Memo

Re: Consultation on an Application

Planning Application Ref: PL/25/0784

Proposal: Two storey side and rear + single storey front and rear extensions following the demolition of a single storey side extension.

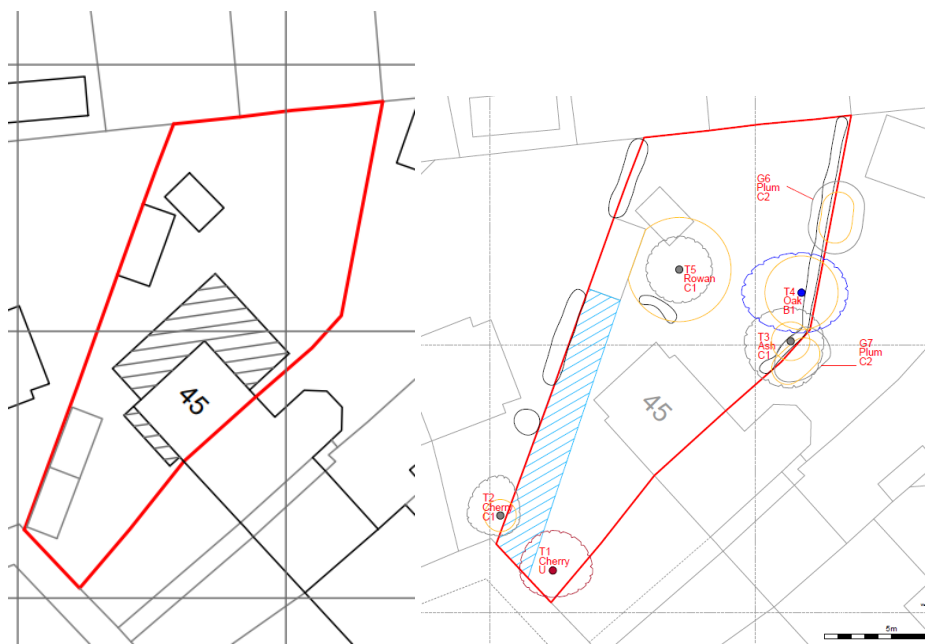
I note a replacement Silver Birch has been proposed to replace T5 which is acceptable. The stock size is 12-14cm in girth, it should be noted that the replacement tree should also be a minimum of 3m in height at the time of planting. However, this can be dealt with as part of a landscape condition. In the meantime, the applicant may wish to consider if they want this replacement in the middle of the garden (I assume the arb consultant discussed location first before showing this).

No Tree Protection Plan has been submitted. I am unclear as to why this hasn't been provided when it is a requirement to adequately protect on and off-site trees. Whilst an example of tree protective fencing has been provided in Appendix C, this is not sufficient and a TPP is required.

This has now been resolved and the TPP is acceptable.
